HAM6: AS-BUILT

HAM6: AFTER (WITH OMC SHROUD)

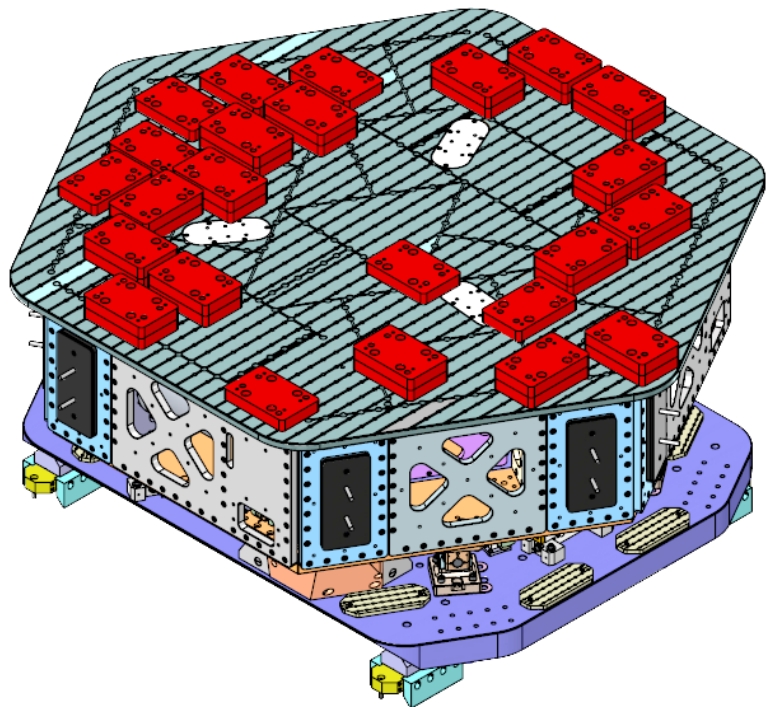
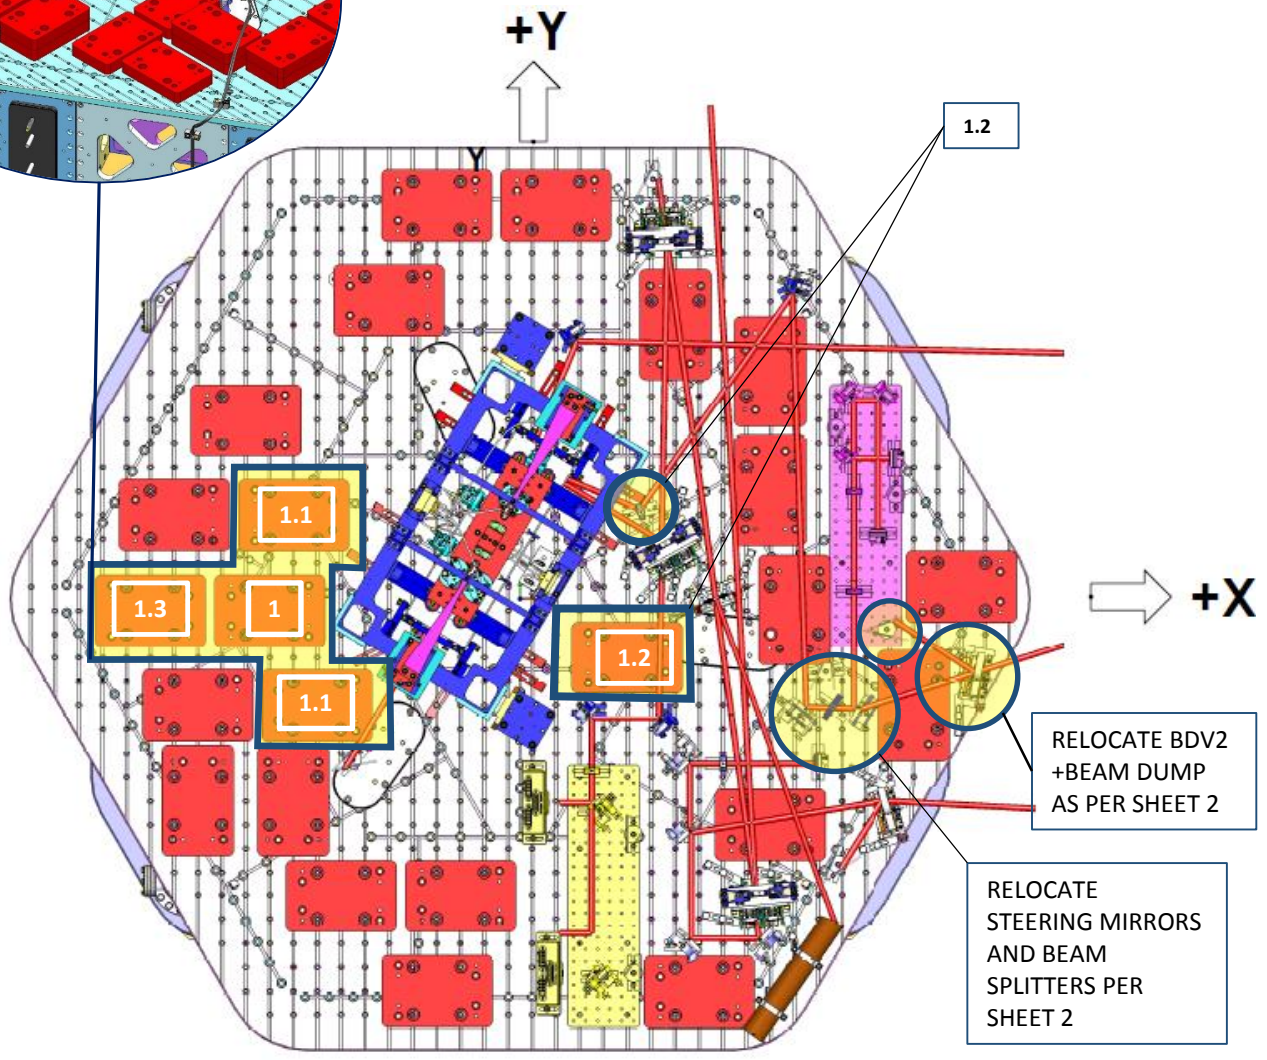
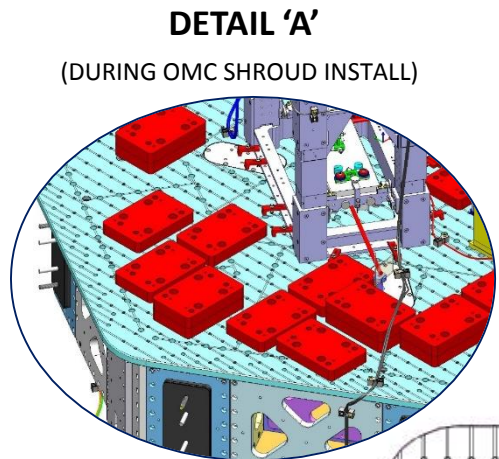
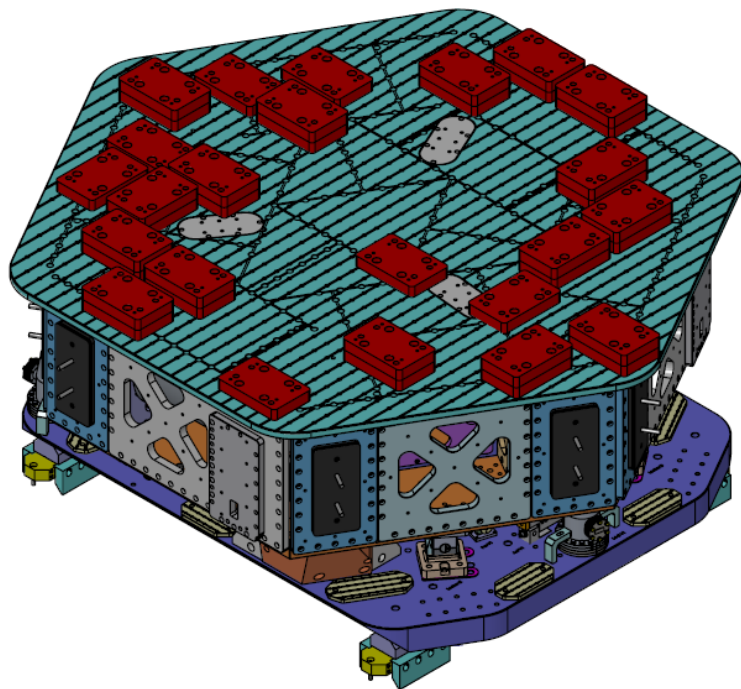
- 1 RELOCATE TOP MASS (PER 1.3) AND REMOVE BOTTOM MASS TO COMPENSATE FOR OMC SHROUD MASS.
- 1.1 REMOVE TOP MASS TEMPORARILY FOR OMC SHROUD INSTALLATION .
- 1.2 REMOVED INDICATED ITEM TEMPORARILY FOR OMC SHROUD INSTALLATION
- 1.3 ADD TOP MASS FROM FROM 1 .

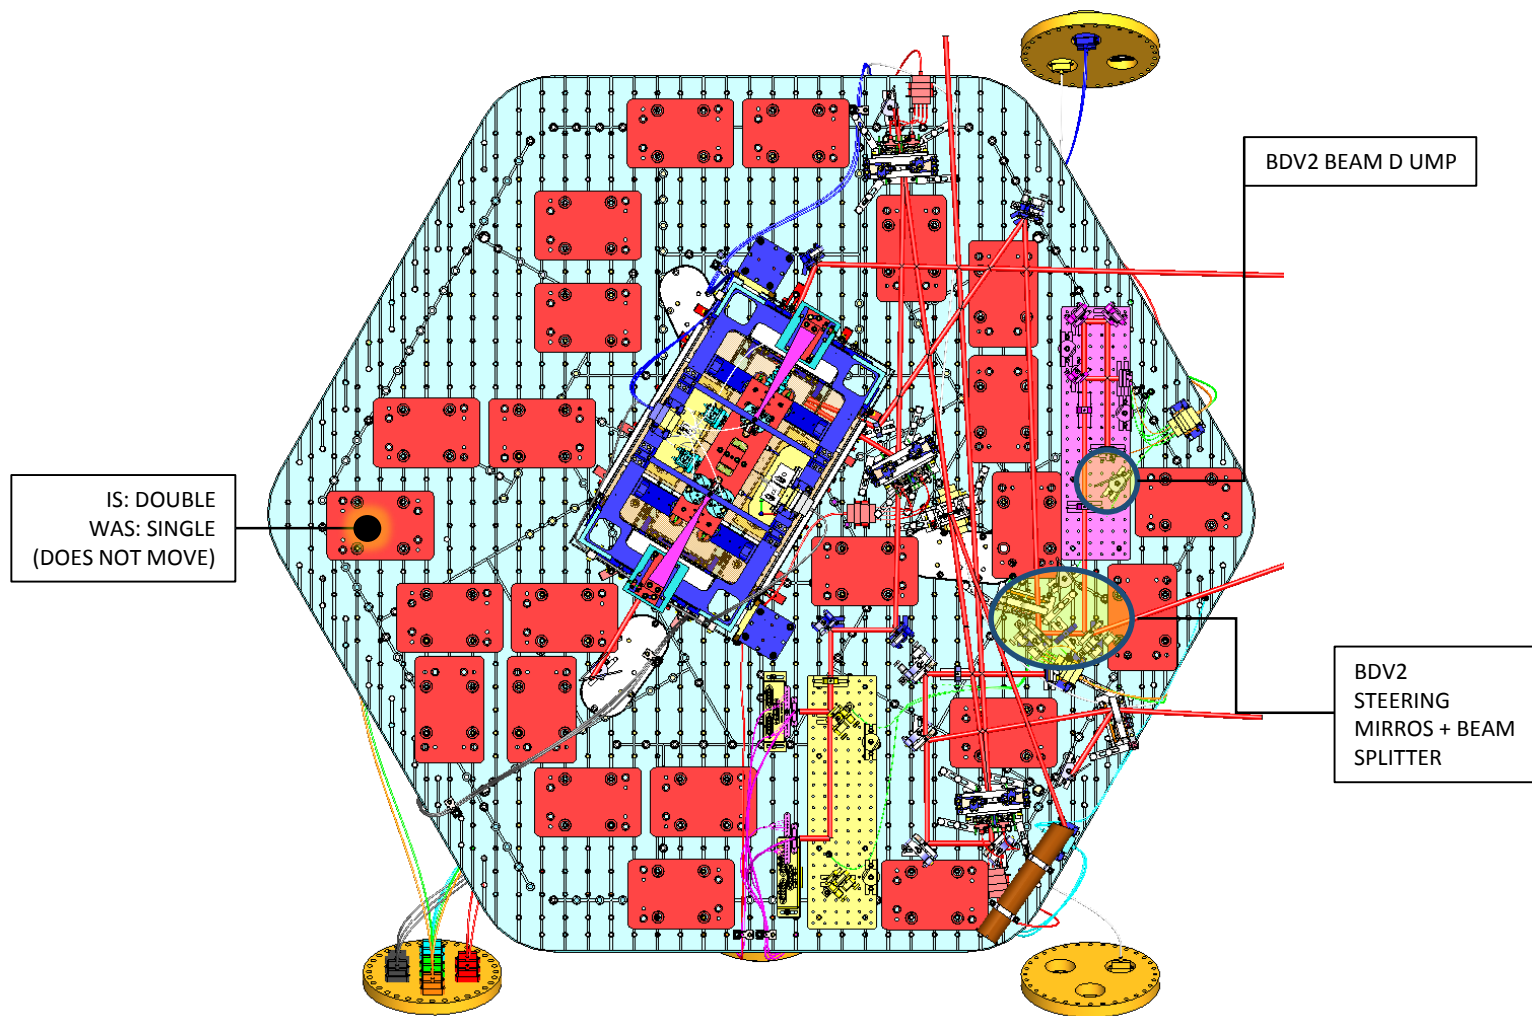
IS:

IS: DOUBLE
WAS: SINGLE
(DOES NOT MOVE)
